RFP 23MCO607

In response refer to RFP No. 23MCO607 Addendum 1 and Response to Questions

ADDENDUM NO: 001

TO: PARKHILL
FROM: PLANHOLDERS
PROJECT NAME: COUNTY COURTHOUSE, 11TH
FLOOR PARTIAL INTERIOR
FINISH OUT
PROJECT NO.: 40451.22
DATE: 5/17/2023

A1 11TH FLOOR - ANNOTATED/DIMENSIONED FLOOR PLAN
1/8" = 1'-0"

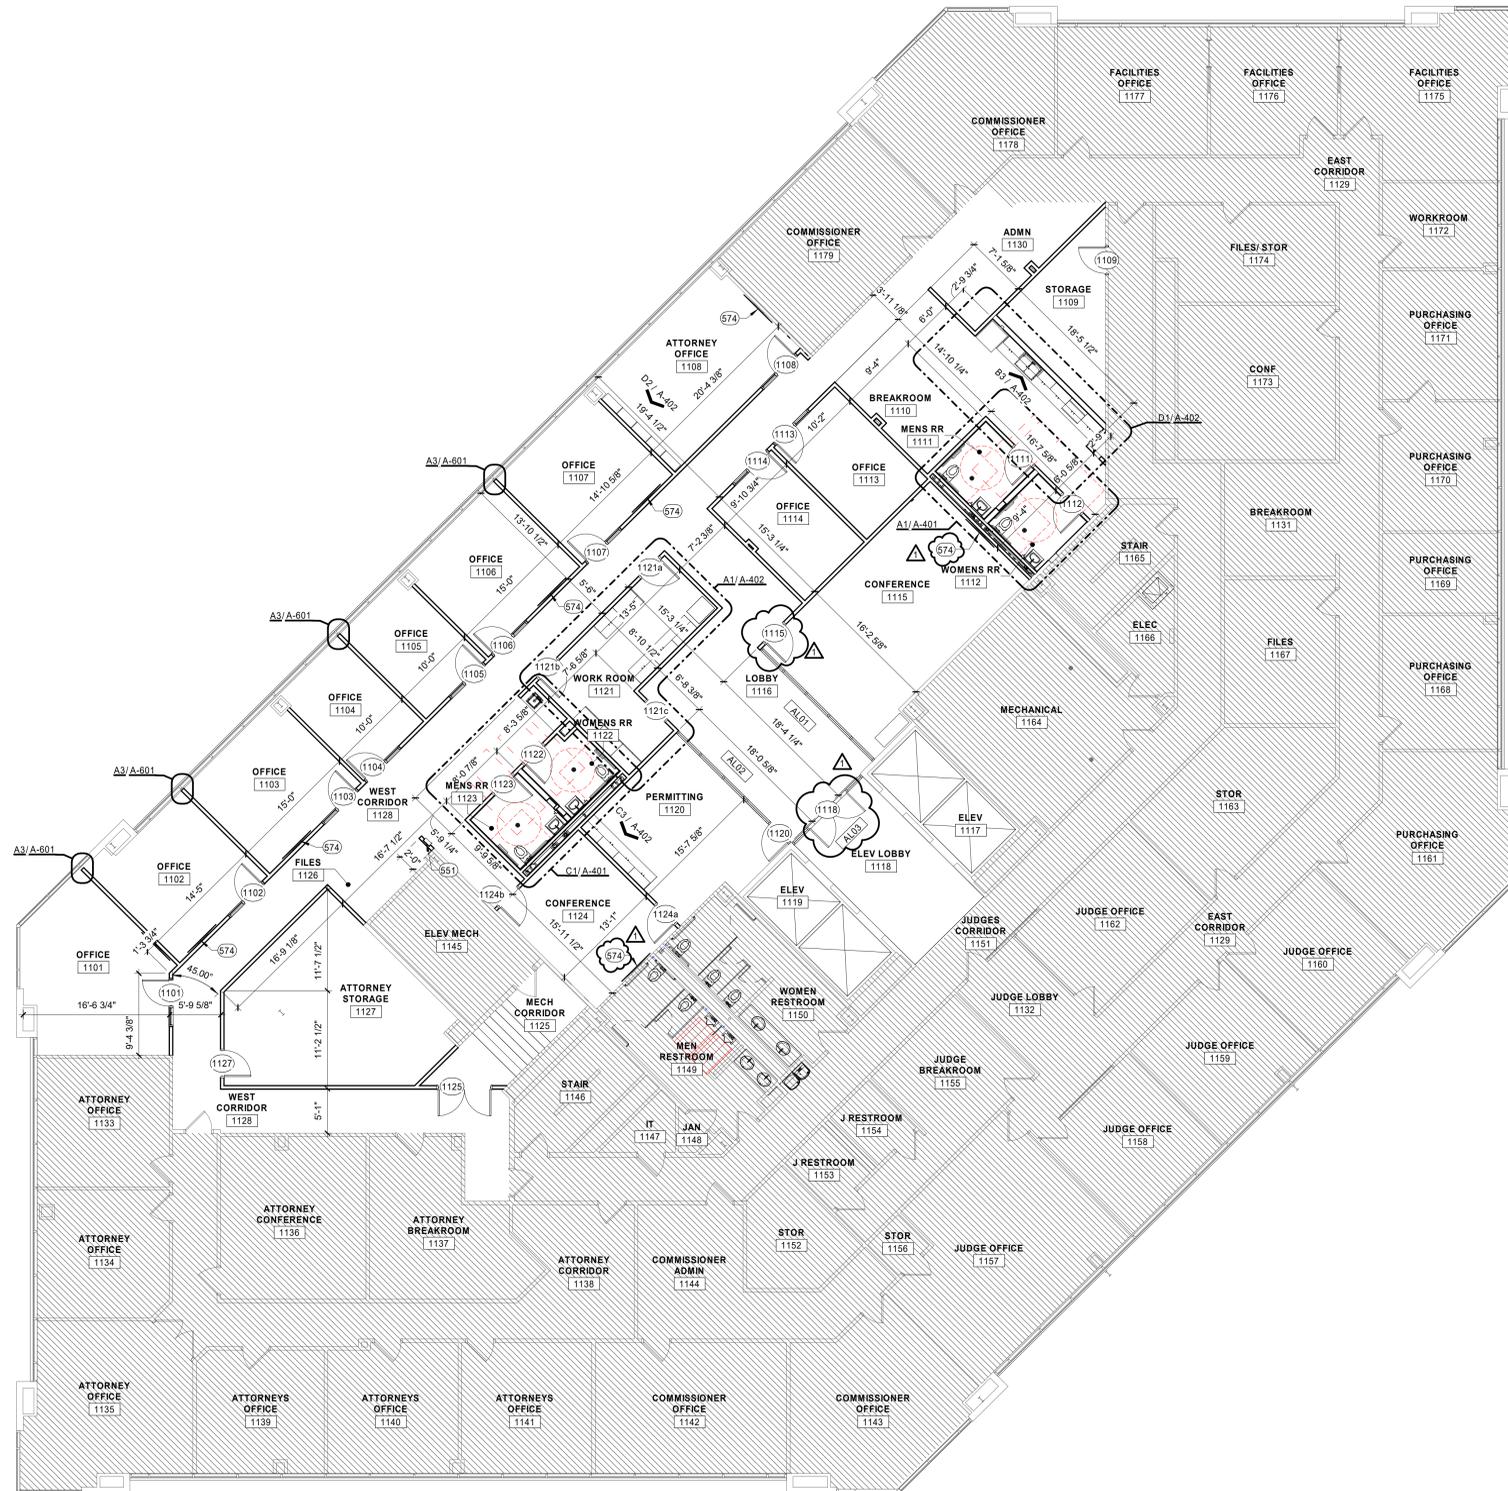
11. Door 41 is not shown on the floorplan, probably the entry from the elevator lobby?

15. Conference 1115 & 1124 seem to indicate blocking for television but do not have any notation, please clarify.

Correct, double door into elevator lobby will be renumbered and tagged 1118.
Reference A-111.

Keynote 574 added to both televisions on sheet A-111.

Door & Glazing
Schedule
A-601

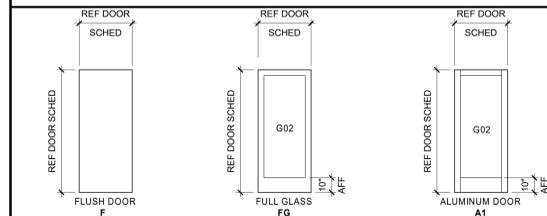
10. Door 1115 seems to be an aluminum door or a wood door in a hollow metal frame, which one?

24. Door 1115 is an aluminum door called out type F (Flush), but the other aluminum doors have a type of A1 (aluminum door). Should this door also have a type of A1?
Door will be wood and will remain F (Flush). Reference A-601.

Wood Door – Reference A-111 & A-601

Electrical
Abbreviations &
Legend
E-001

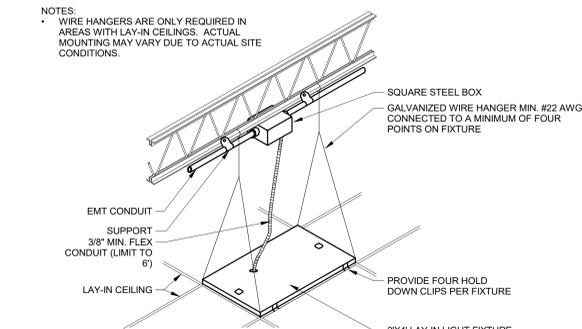
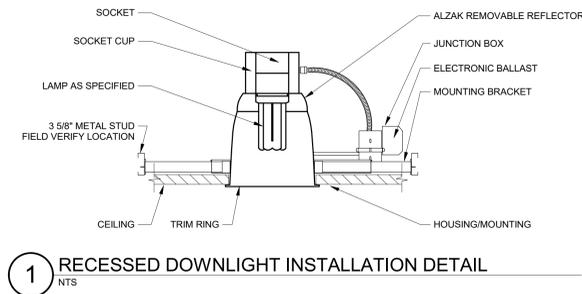
12. EXIT lights are not shown on the lighting plan or fixture schedule. Please advise.

Exit signs have been added to the lighting plan and fixture schedule in this addendum, see Sheet E-111, herein.
